**IGEM/UP/10 Edition 4
COMMUNICATION 1774
2014**

The following Amendments (March 2016) apply to all copies of IGEM/UP/10 Edition 4 published in 2014.

**IGEM/UP/10 Edition 4
COMMUNICATION 1774
2014
AND COMMUNICATION 1786
2016**

The following Amendments (February 2017) apply to all copies of IGEM/UP/10 Edition 4 published in 2014 and 2016.

FIGURE 2 – EXAMPLE OF VENTILATION DISTRIBUTION FOR A PLANT ROOM WITH LOUVRED DOORS AND VENTILATION ◀.

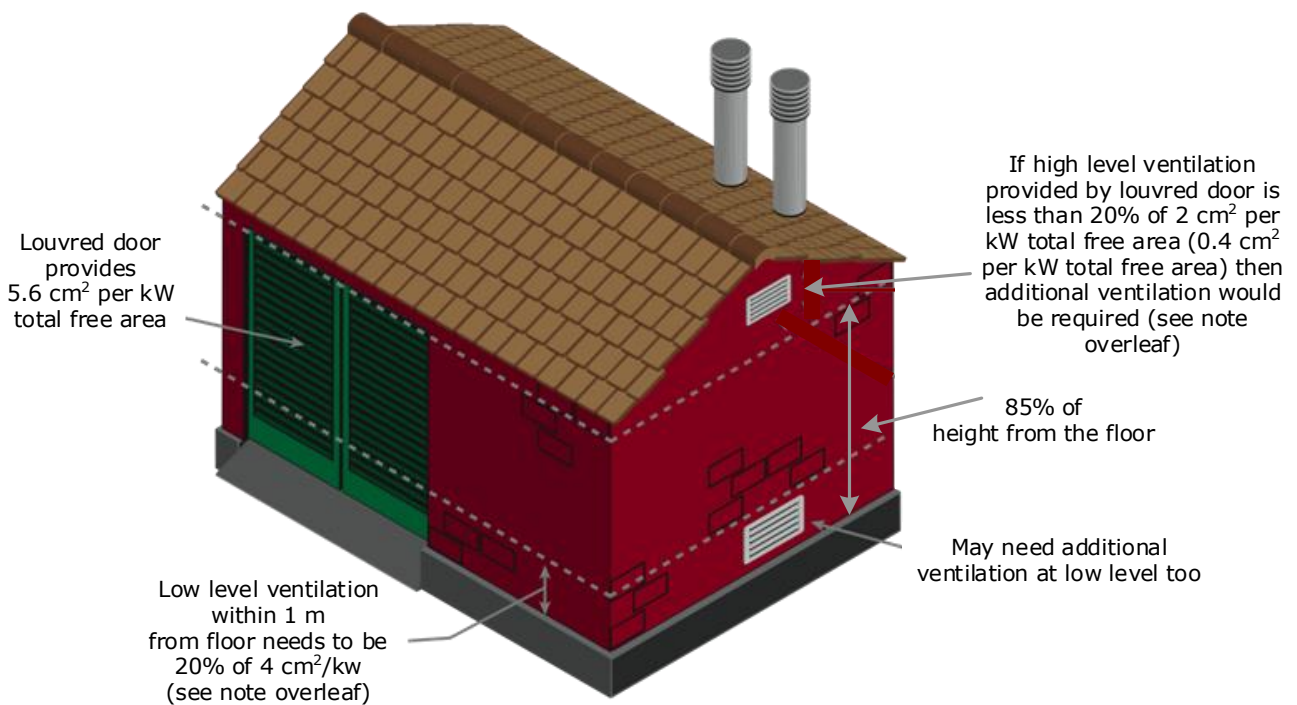
FIGURE 2 Delete entire Figure. Substitute:

➤ **FIGURE 6 – EXAMPLE OF TERMINATION POSITIONS ◀**

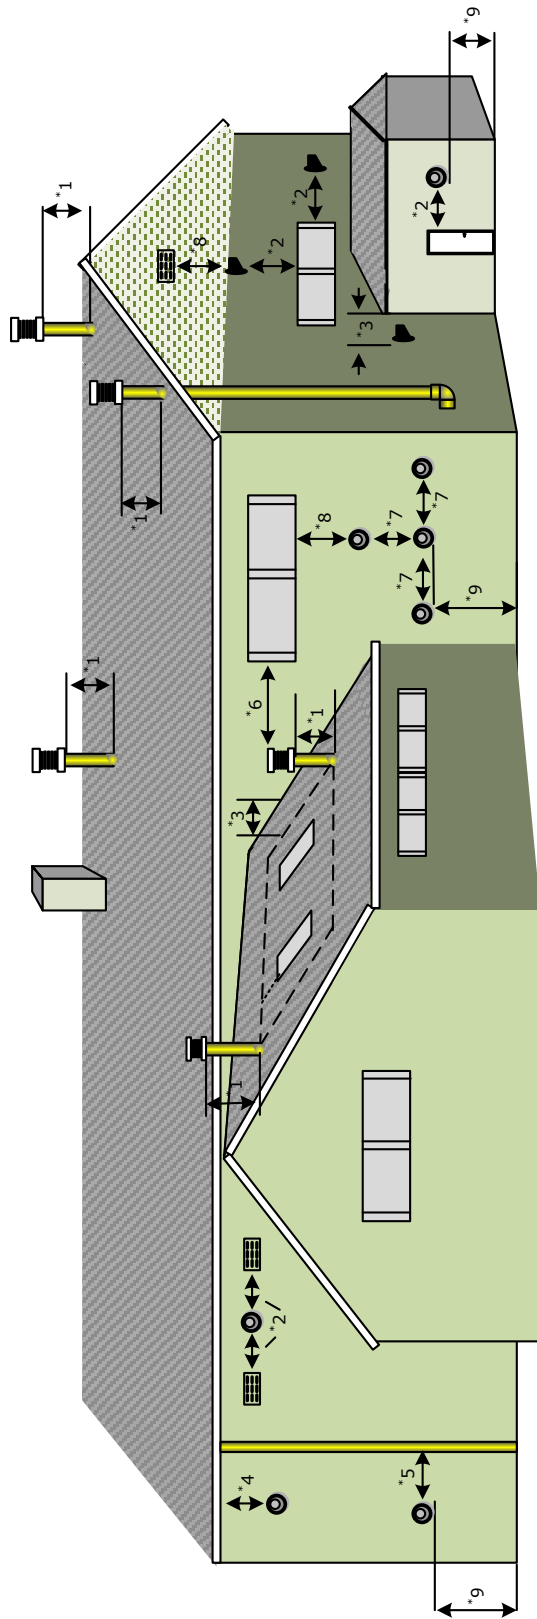
FIGURE 6 Delete the Figure. Substitute:

- * 1 - Minimum termination height for ridged and flat roofs, see clause 8.7.2 and Figures 10A and 10B.
- * 2 - Minimum horizontal termination distance from openings i.e. doorways, windows, ventilation grilles, etc., see clause 8.7.1.3 and Figure 7.
- * 3 - Minimum horizontal termination distance from adjacent walls or obstructions, see clause 8.7.2.7.
- * 4 - Minimum distance to be 200 mm for fan assisted appliances, 300 mm for room sealed natural draught appliances, see BS 5440 and clause 8.7.3.3.
- * 5 - Minimum distance to be 150 mm, see BS 5440 and clause 8.7.3.3.
- * 6 - Minimum termination distance from openings i.e. doorways, windows, ventilation grilles, etc., see clause 8.7.2.2.
- * 7 - Minimum distance of centres of flue terminal, see manufacturer's instructions.
- * 8 - Minimum distance below terminal or opening 2.5 m, see Figure 7.
- * 9 - See Sub-section 8.7.3.

FIGURE 8 – HEIGHT 'X' OF THE FLUE TERMINAL LOCATED ON A ROOF FOR APPLIANCES UP TO A NET HEAT INPUT OF 333 kW ←.

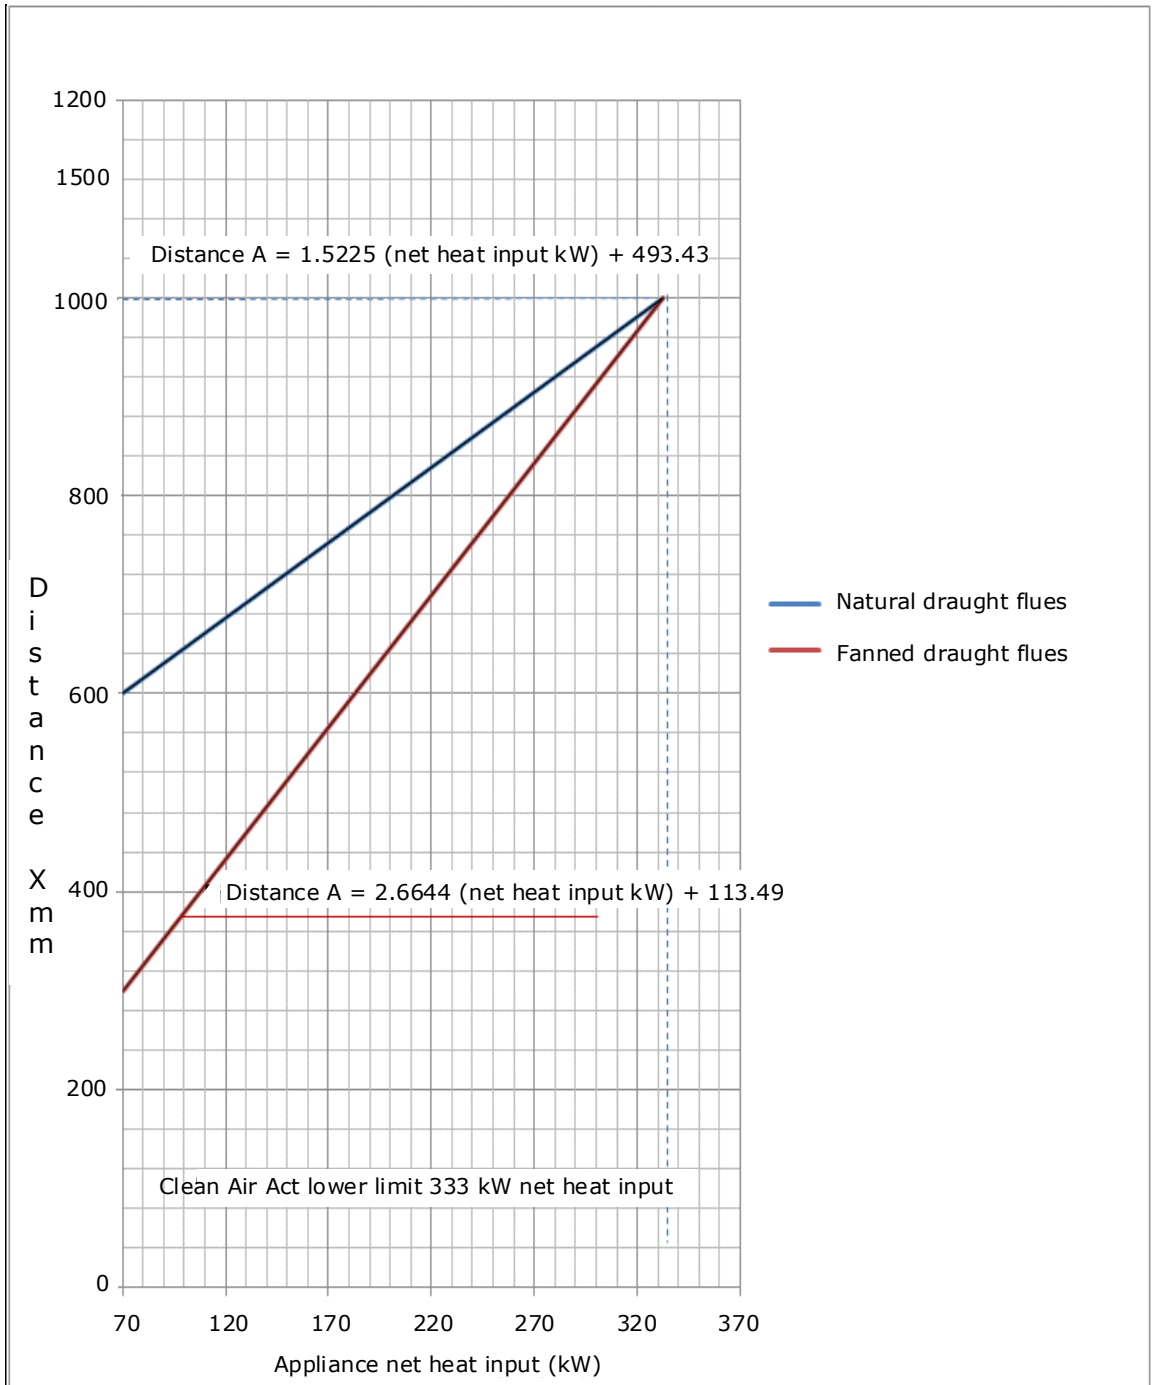
FIGURE 8 Delete the Figure. Substitute:

Note 1: The type of flue does not necessarily reflect the type of connected appliance.

Note 2: The equations on the graph are represented by the appropriate plotted line.

FIGURE 10A – TERMINATIONS FOR RIDGED ROOF CONFIGURATIONS ◀

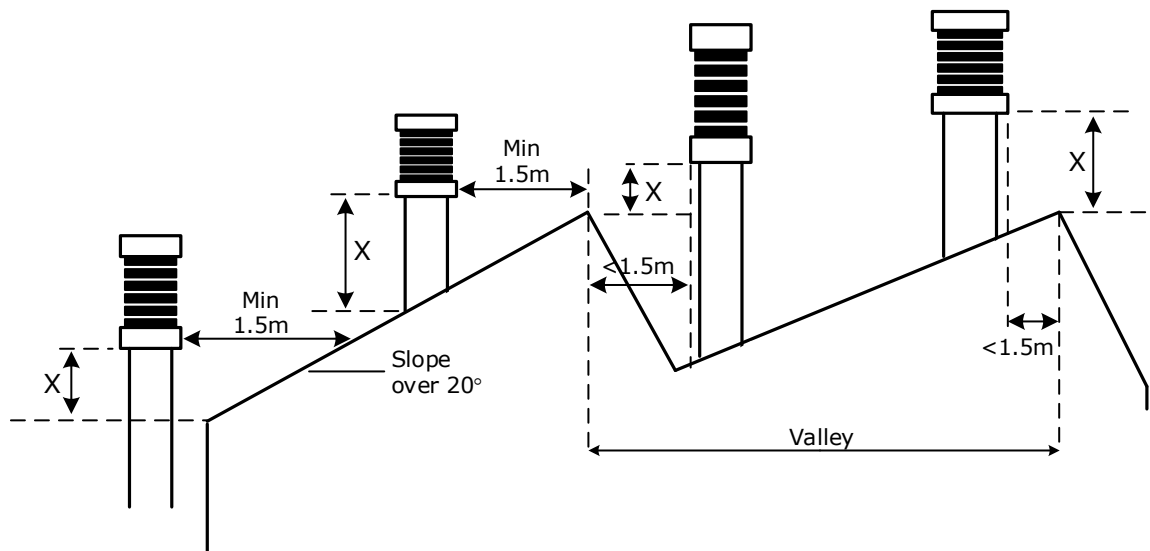
Delete the Figure. Substitute:

Note 1: For dimension X – see Figure 8.

Note 2: A pitched roof has a slope of greater than 20° from the horizontal.

FIGURE 11A – FLUE TERMINALS ON AN ADJACENT BUILDING ◀

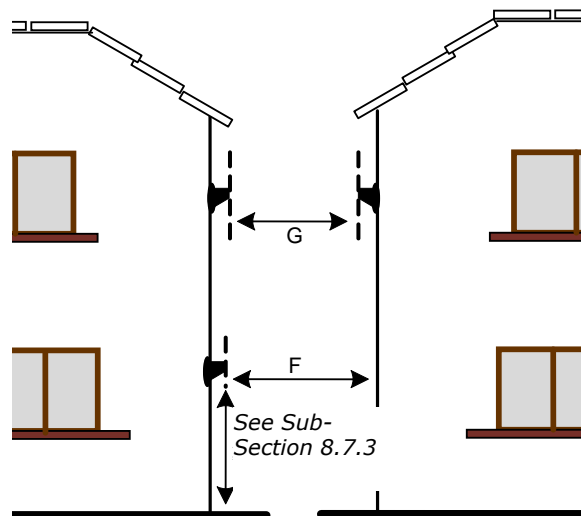
FIGURE 11A Delete the Figure. Substitute:

Horizontal flue distance from opposing wall and other terminals
(see Figure 12)

FIGURE 11B – HORIZONTAL FLUE TERMINALS ENCLOSED BY TWO OR MORE VERTICAL WALLS (PLAN VIEW) ◀

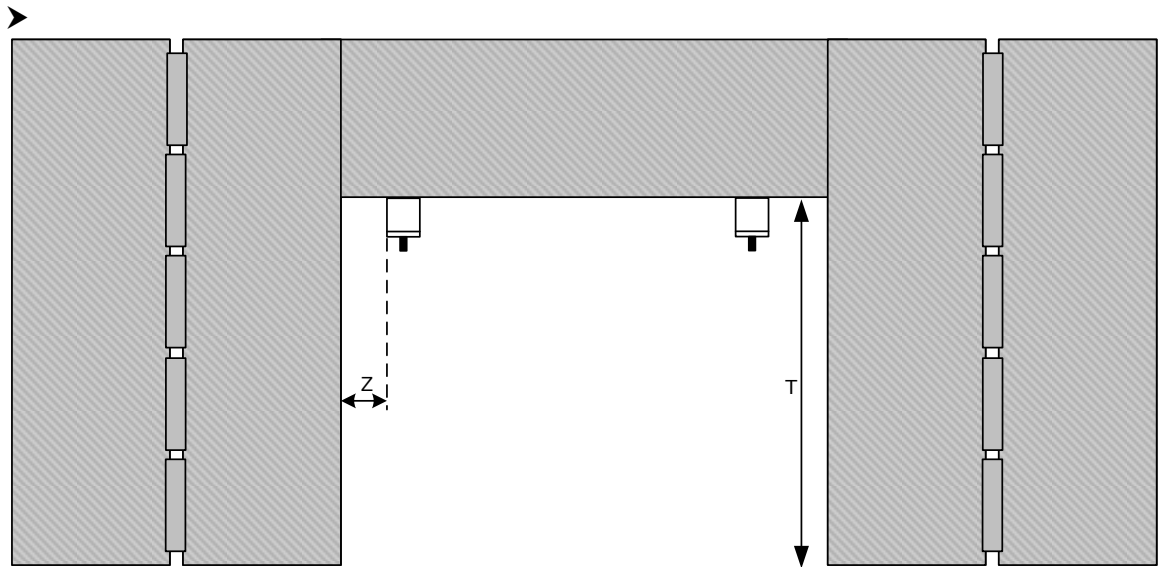
FIGURE 11B Delete Figure. Substitute:

Z See clause 8.7.3.10 and Figure 11A.

T Maximum depth of the building. See clauses 8.7.3.10, 8.7.3.11 and Figure 11A.

FIGURE 12 – MINIMUM SPACING OF ROOM SEALED APPLIANCE FANNED DRAUGHT TERMINALS FROM OPPOSING FLAT SURFACES 'F' AND OTHER TERMINALS 'G' <

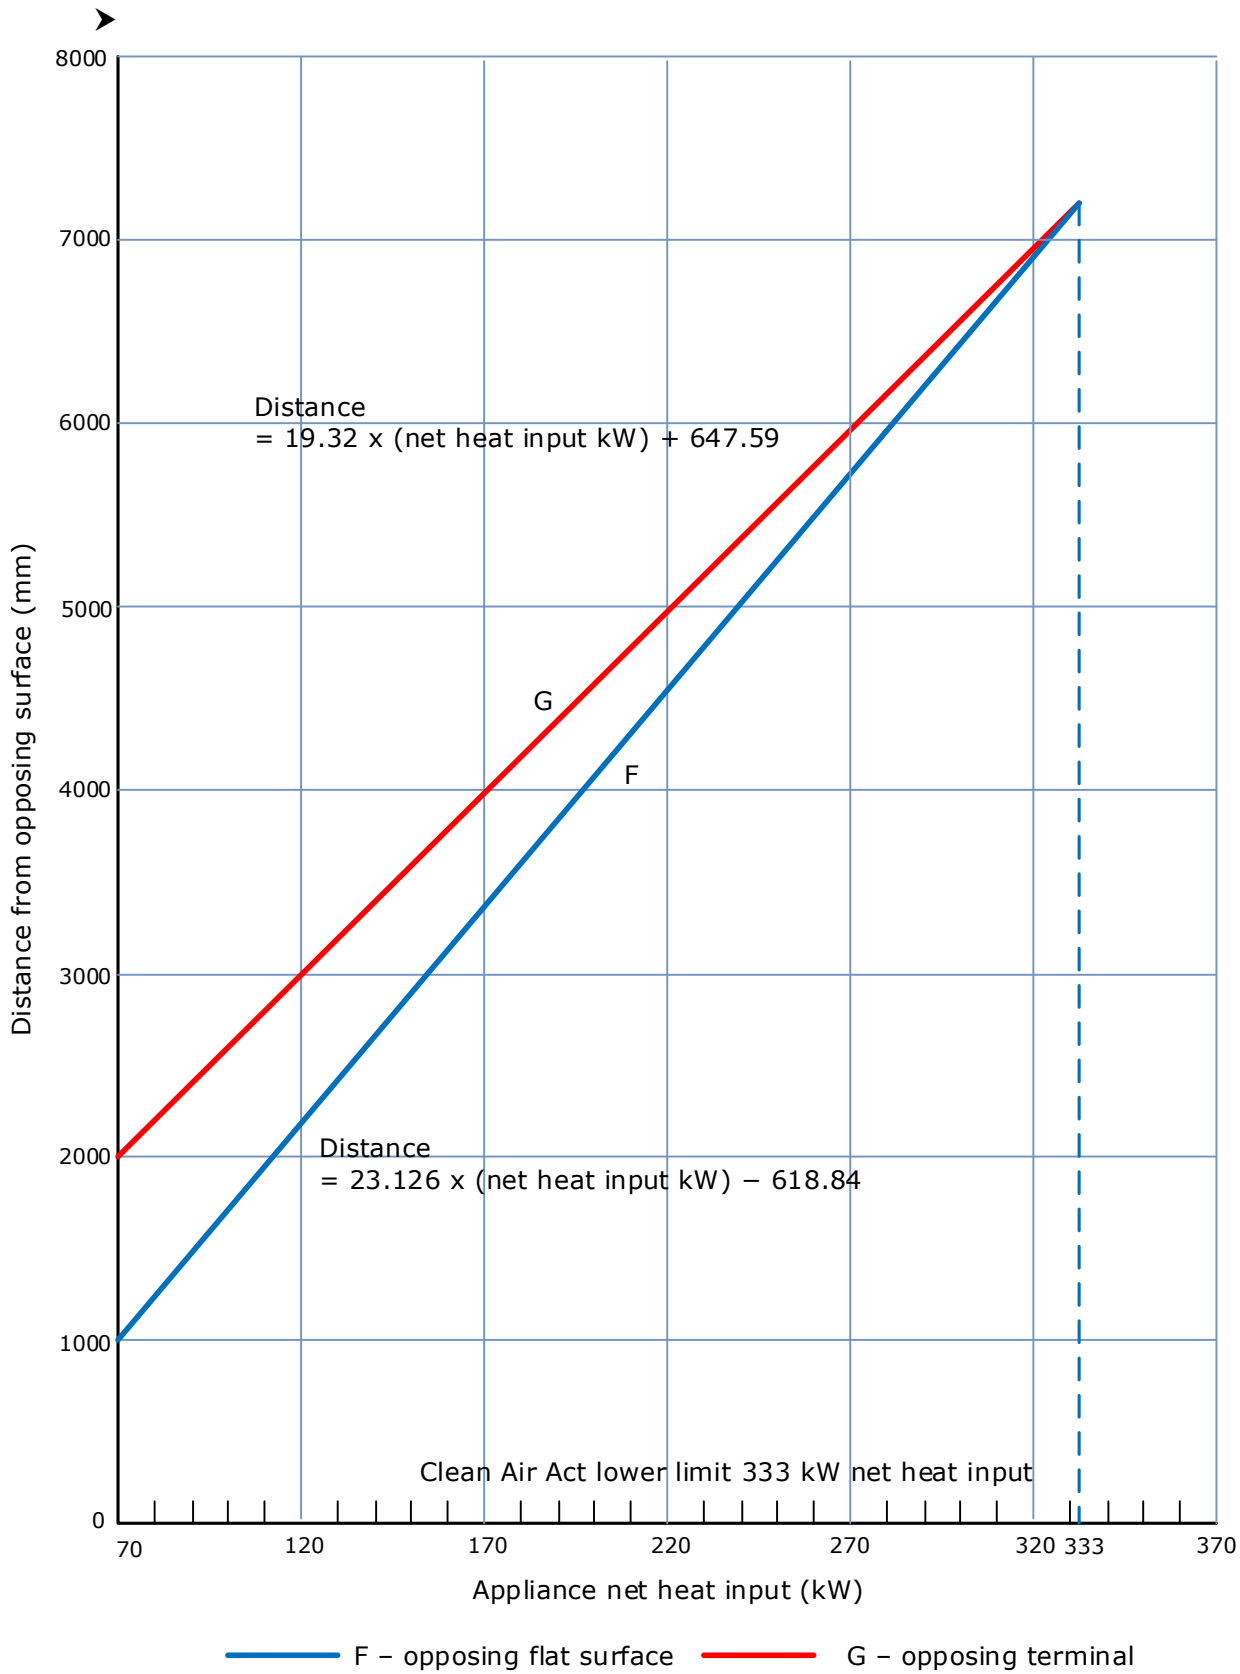
FIGURE 12 Delete the Figure. Substitute:

Note: The equations on the graph are represented by the appropriate plotted line.

FIGURE 13 – Delete the Figure. Substitute:

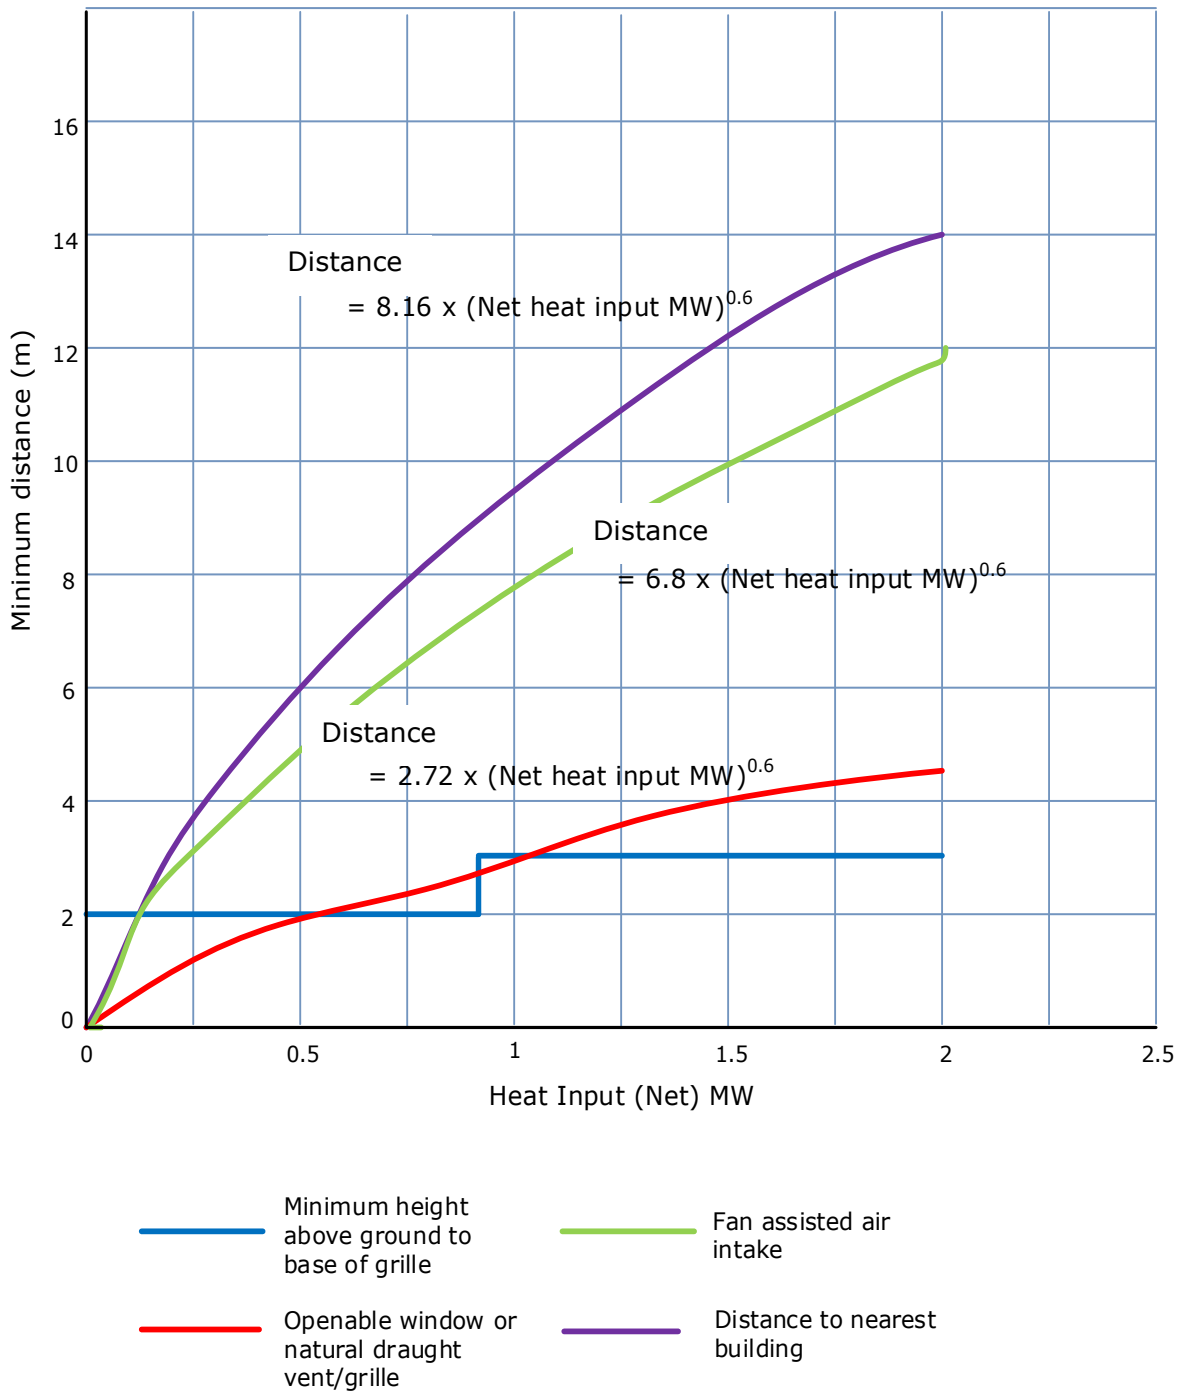
Figure 13 – Note – Delete Note. Substitute:

➤Note 1: The equations on the graph are represented by the appropriate plotted line.

Note 2: The distance needs to be rounded up to the nearest metre. ◀

FIGURE 7 – THE MINIMUM DISTANCE OF FLUE TERMINAL(S) FROM ANY OPENING INTO A BUILDING <<

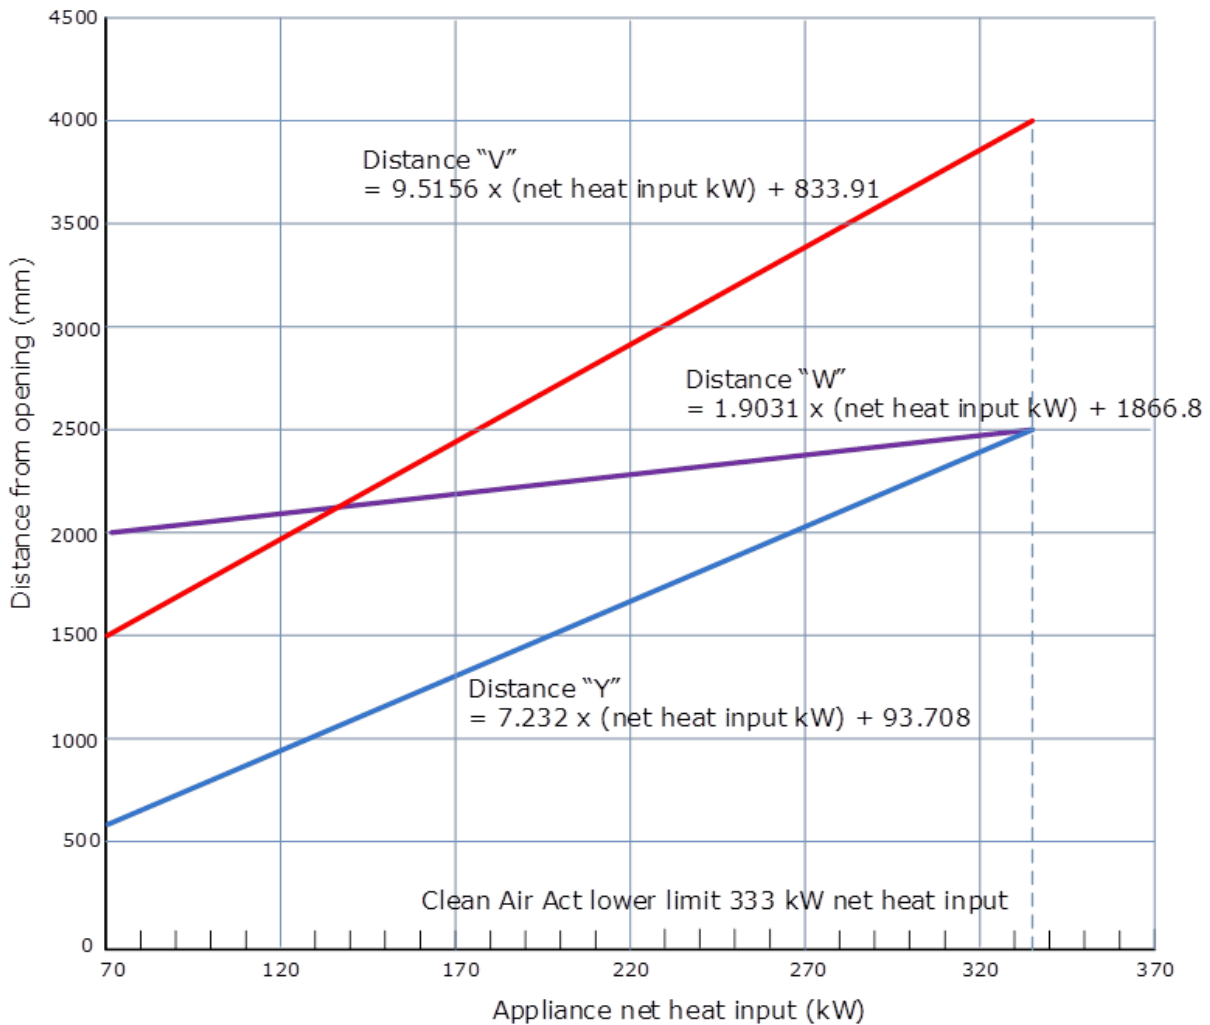
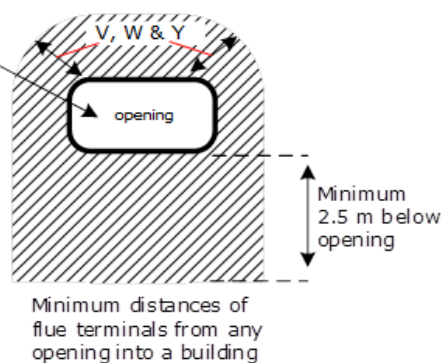
FIGURE 7 Delete the Figure and substitute:

- V is for fan draught and open flued appliances
- W is for balanced or room sealed appliances - natural draught
- Y is for room sealed appliances - fanned draught

Note 1: All vertical flues will terminate above roof level and not be nearer any opening than distance V for open flued, V/Y for fanned draught or W for natural draught appliances.

Note 2: The equations on the graph are represented by the appropriate plotted line.

Note 3: For terminal locations below the opening, V; W and Y are not diagonal dimensions but a horizontal or vertical distance from the terminal. The prohibited area below an opening is the width of V; W or Y and 2.5 m vertically.
